Pricing

Product

Carton Label

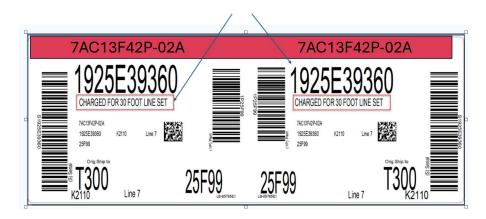
I'm happy to share that we are temporarily increasing the factory pre-charge of R-454B refrigerant in residential ducted air conditioners and heat pumps from 15-feet to 30-feet.

- No changes will be made to catalog numbers
- Units with additional refrigerant charge will be identified through model number revisions and serial number tracking
- Language is being added to box labels as well; see example below
